Eye on Evanston: Thoughts on Design | Design Evanston reviews proposal for 910-938 Custer Avenue

by Jack Weiss and David Galloway, Design Evanston October 16th, 2024

On Oct. 7, Design Evanston professional members met to evaluate the proposed <u>910-938 Custer</u> <u>Ave. project</u>, as presented by Max Charles Davidson of CDG Capital, Paul Dincin of Catapult Real Estate Solutions and Andy Ahitow of CityPads.

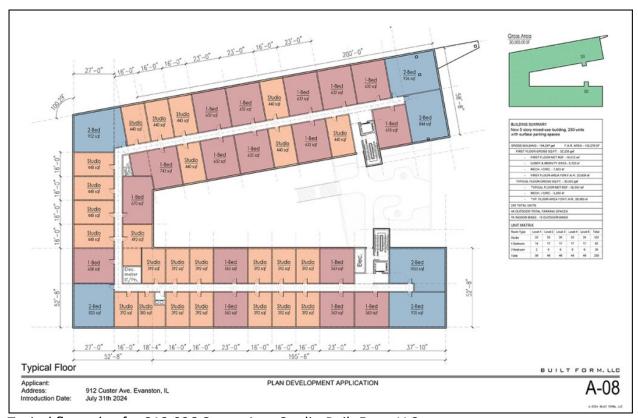
9. The project should be a contributor to the City of Evanston's goals to be energy self-sufficient.

See criteria No. 4 above.
